DESIGN REVIEW COMMISSION STAFF REPORT

MEETING: April 19, 2017

SUBJECT: **Pacheco Plaza Chase Bank
Design Review Commission
File: P2016-071; Design Review
APN: 160-190-13, 402 Ignacio Boulevard**

Typical Storefront Elevation

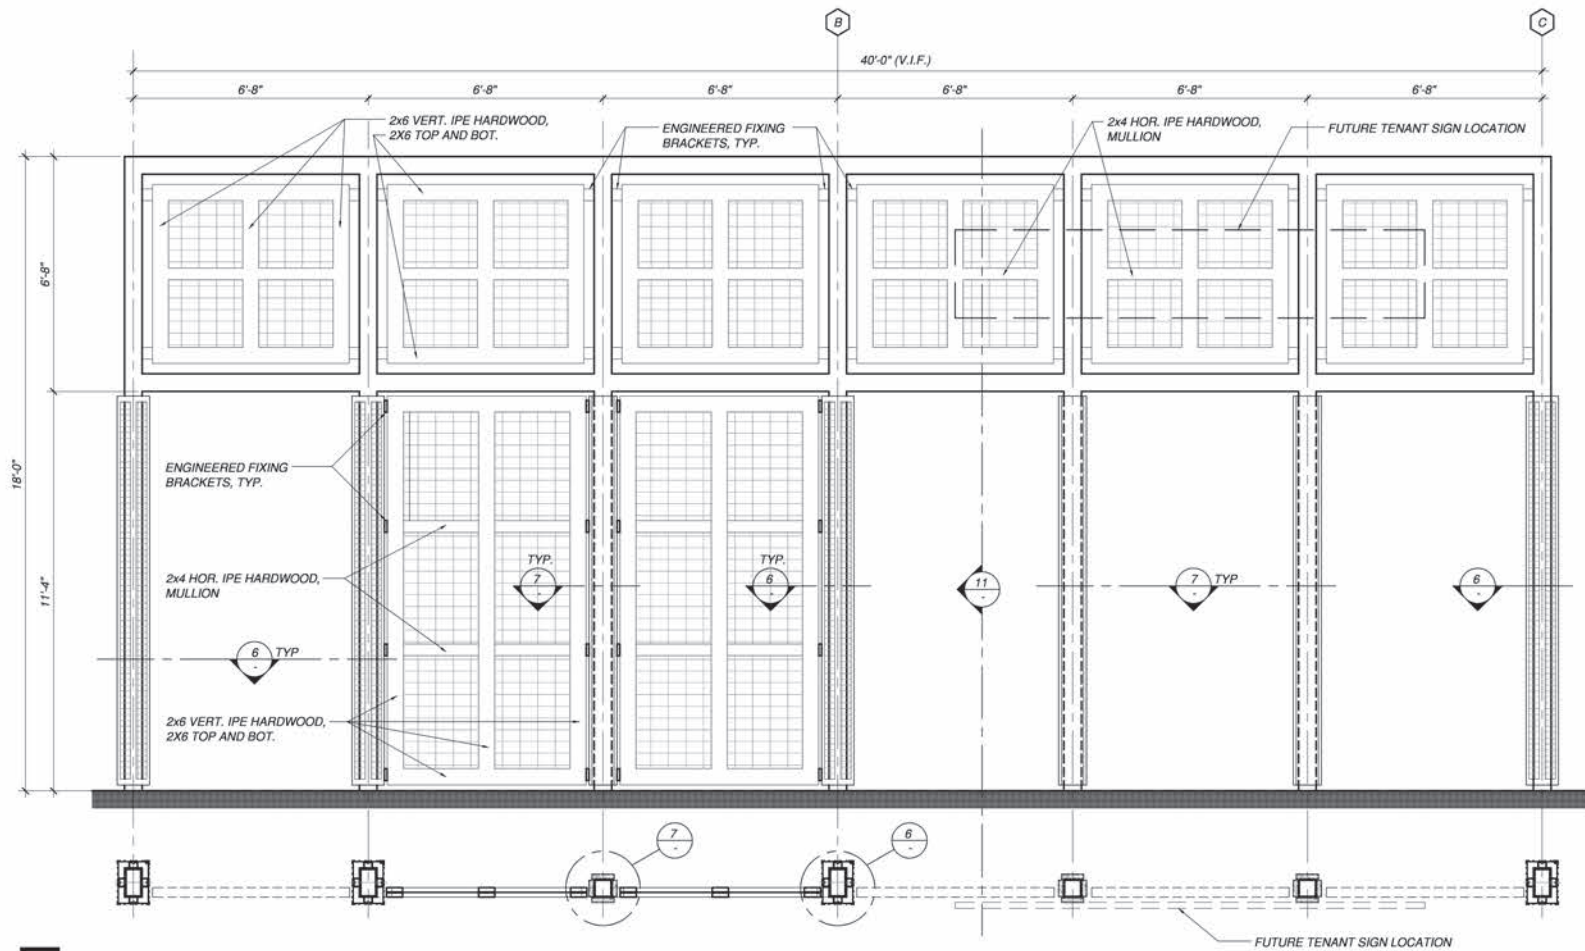
- 7. A6.0/ A9.0/ A9.1 – Reference only sheets
 - a. Plaza detail sheets added to sheet set for reference.
 - 8. 1 of 1 -Preliminary Grading Plan
 - a. Removal of Trash Enclosure.
